## DPR 25-18: Walmart Market Avon Avenue

Planning & Building Department Staff Report

For Hearing on February 23, 2026

# Exhibit B – Revised Site Plan (5-January-2026)

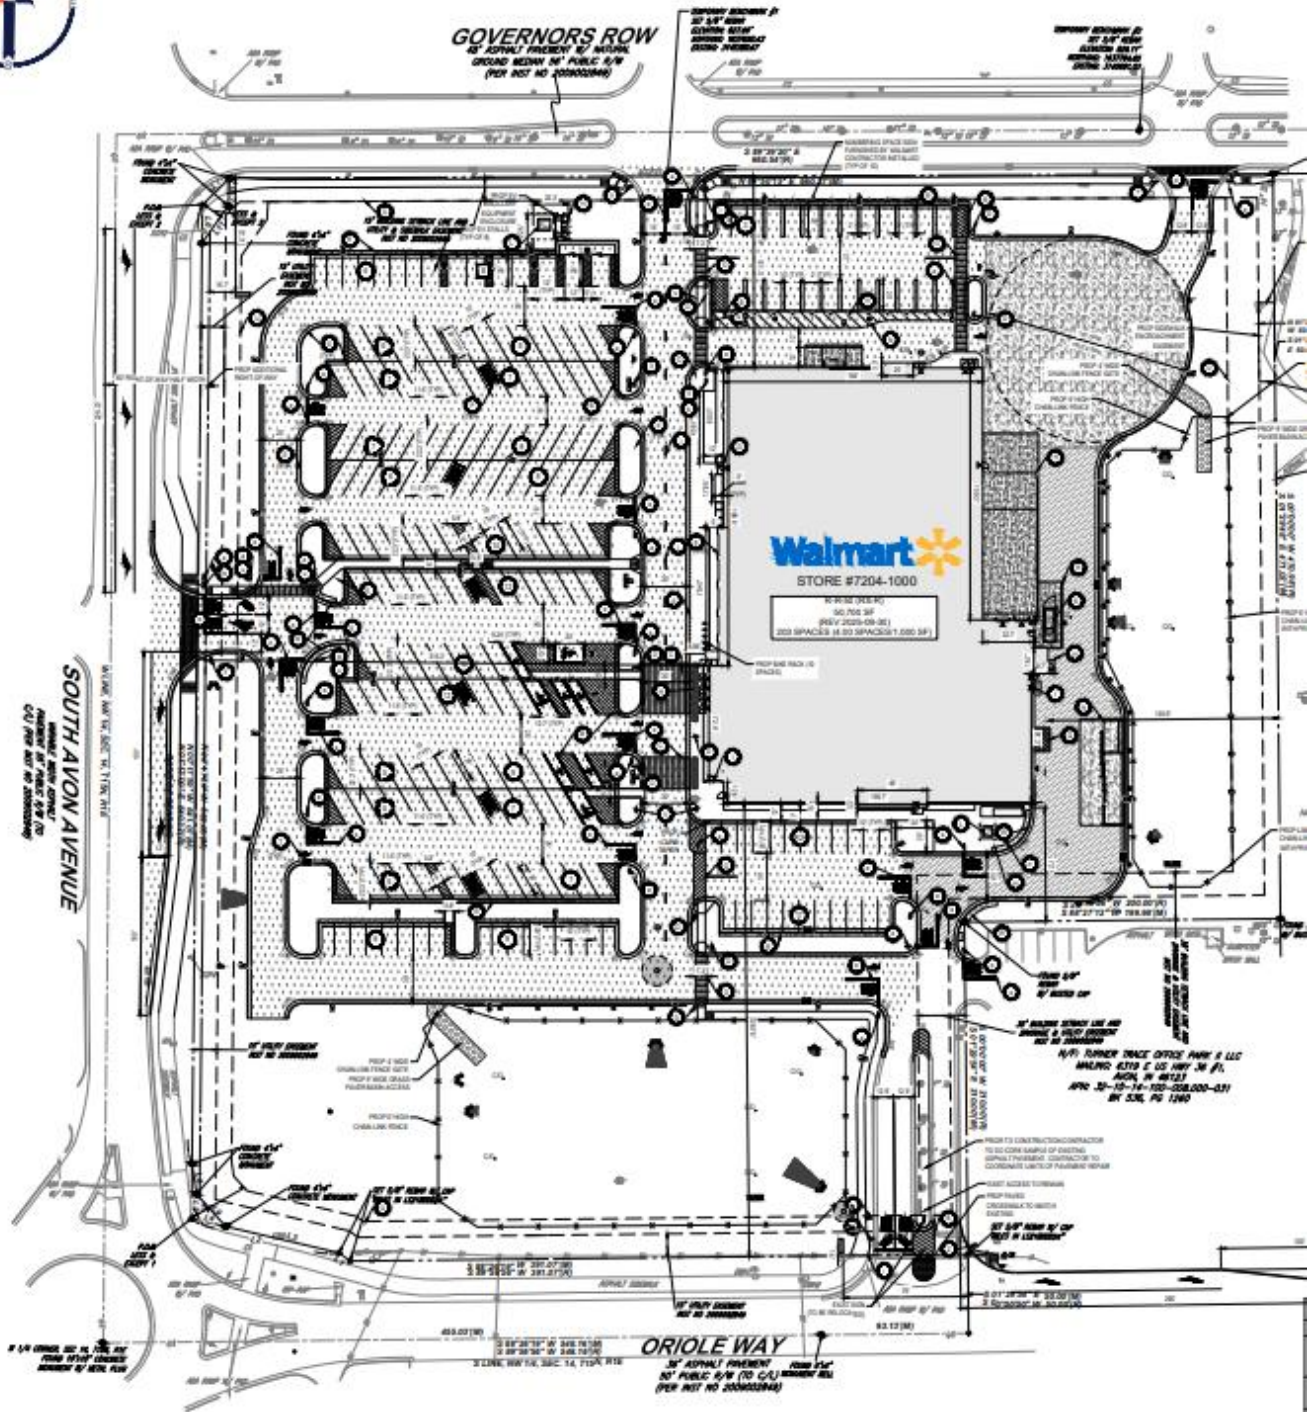
<p><b>I. STAFF COMMENTS (JANUARY 26, 2026)</b></p>	<p>This request would allow for construction of a ~50,000-square foot retail building oriented to Avon Avenue to be occupied by a grocery store, with a drive-through pharmacy on the north (side) façade. A 225-space parking lot would be mostly to the west (front) of the building, with approximately two dozen of those spaces located on each side (north and south) of the building, The spaces on the north side of the building, adjacent to Governors Row, are indicated for online order pickup. Loading, trash enclosures, and a stormwater retention pond</p>

- a) **Parking:** The site plan indicates the provision of 225 off-street vehicle parking spaces, with eight (8) of those being reserved accessible spaces. UDO Table 6.3 specifies that a minimum of 2.5 spaces per 1,000 square feet of gross floor area for a grocery store or other retail use, thus, a minimum of 127 spaces would be required for the proposed 50,700-square foot store. Based on the overall number of spaces provided, a minimum of seven (7) reserved accessible spaces would be required.

- b) **Loading:** Retail buildings between 7,500 and 75,000 square feet are required to provide a minimum of one (1) dedicated loading space. The site plan indicates two (2) dedicated loading spaces meeting the spatial requirements for tractor-trailer deliveries.

- c) **Bicycle Parking:** The UDO requires one bicycle rack per every twenty (20) required vehicle parking spaces, thus, six (6) bicycle racks would be required. While the revised site plan shows bicycle racks in a compliant location, the plan only indicates five racks. At least one additional rack would be required.

## Exhibit C2 – Areas Deficient of Foundation Planting Requirement

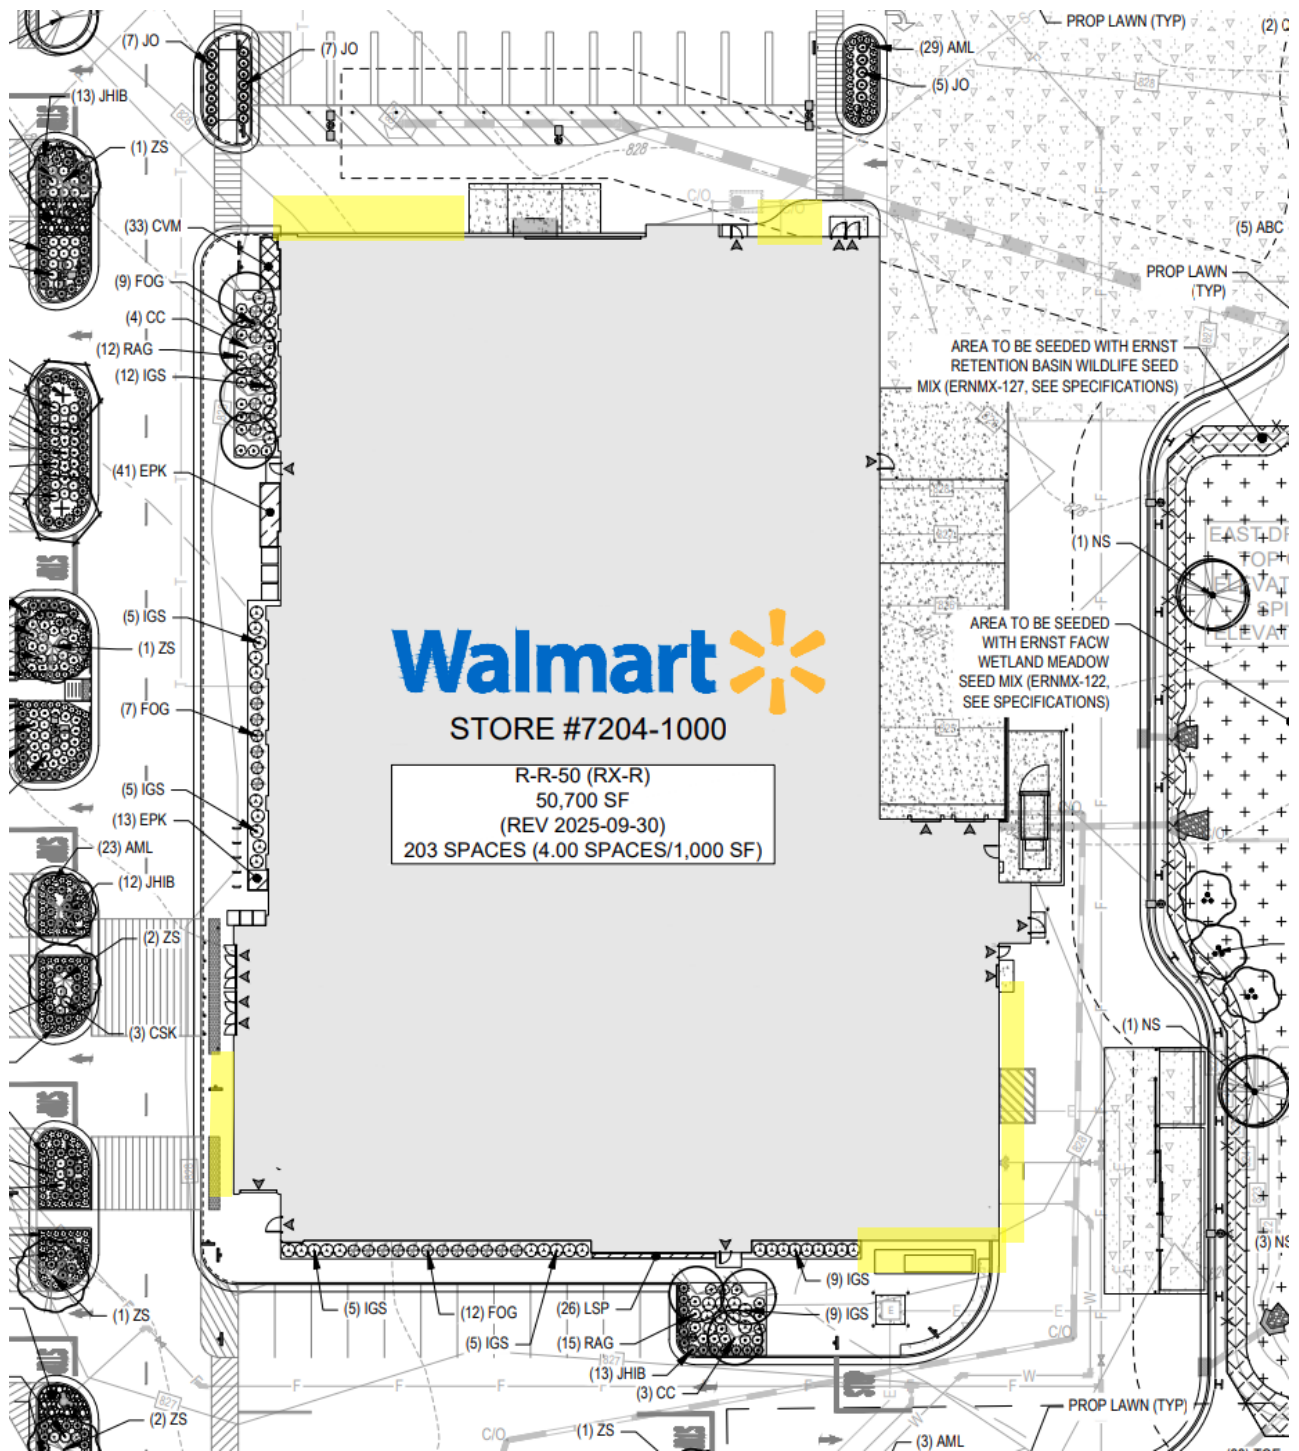
Per UDO 6.5 (A), a minimum five-foot planting area must be provided around the perimeter of the building, excluding access to the buildings, such as loading areas and doorways. The landscape plan submitted subsequent to TAC review has increased the proposed foundation planting areas, but is still deficient along several portions of the building (see Exhibits C1 & C2).

Per UDO 6.7(B)(4), each parking lot landscape island must have a minimum of one tree. The revised landscape plan is still deficient of this standard.

A further revised landscape plan should be submitted to demonstrate compliance with the foundation planting and interior parking lot landscaping requirements.

# Exhibit F – Lighting Plan

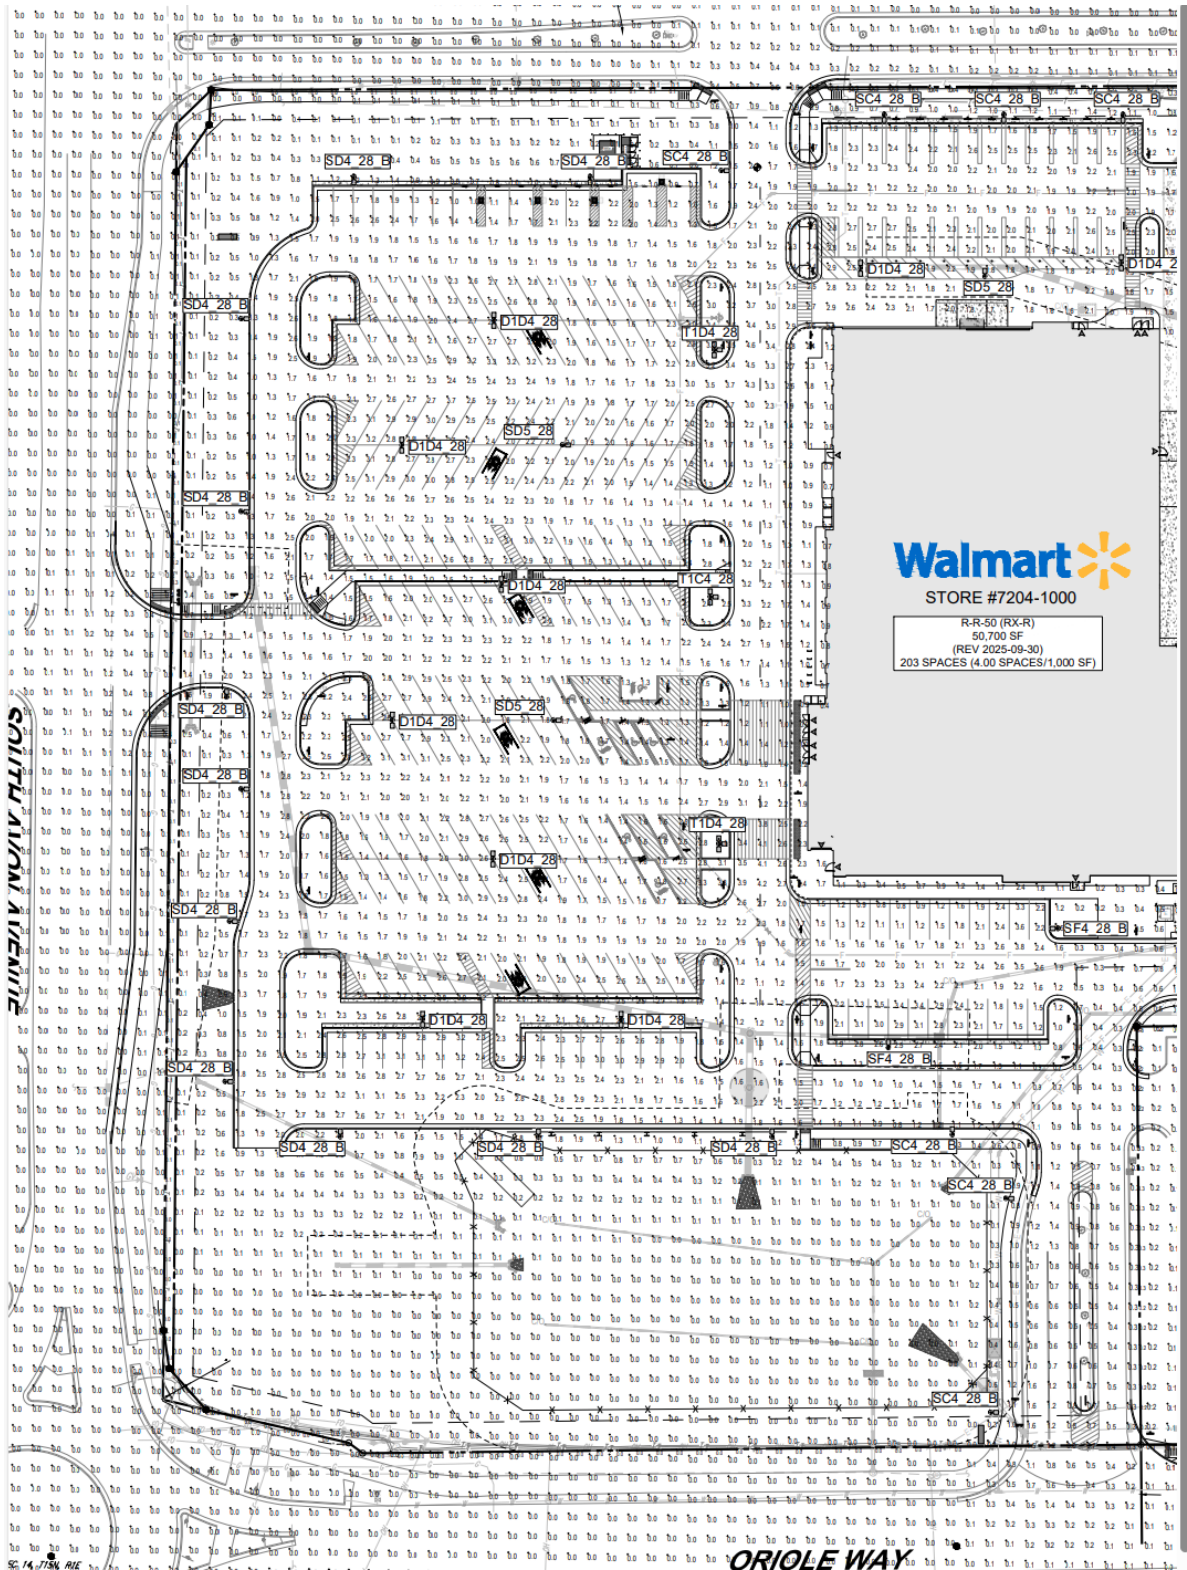
Waiver of Development Standards of UDO 6.10(C), to allow an average parking lot lighting level of 2.16 foot-candles (Fc), which exceeds the 1.6 Fc maximum average allowed.

The Town’s lighting standards allow for a range of lighting levels, and the 1.6 Fc maximum average is in line with the recommendation of the IES, which recommends an average lighting level of 1.0 Fc for parking lots in suburban settings. Excessive lighting adds to light pollution, which can have negative impacts upon the public such as diminishing the quality of night sky views.

Because most developments comply with the standard, it is staff’s opinion that an average lighting level 35% higher than the maximum allowable level would not be harmonious with the purpose and intent of the zoning district.

Waiver of Development Standards of UDO 6.10(A), to allow light spillage of 0.4 foot-candles (Fc) into the abutting rights-of-way, which exceeds the 0.3 Fc maximum allowed.

Staff concurs with the petitioner's assertion that this is a minor deviation, and the Town is generally not opposed to slightly higher light spillage at an intersection (see Exhibit F).

A revised lighting plan indicating an allowable average parking lot lighting level has not been submitted. Therefore, **staff's recommendations for Waivers B & C remain as indicated in the January 26, 2026 staff comments.**
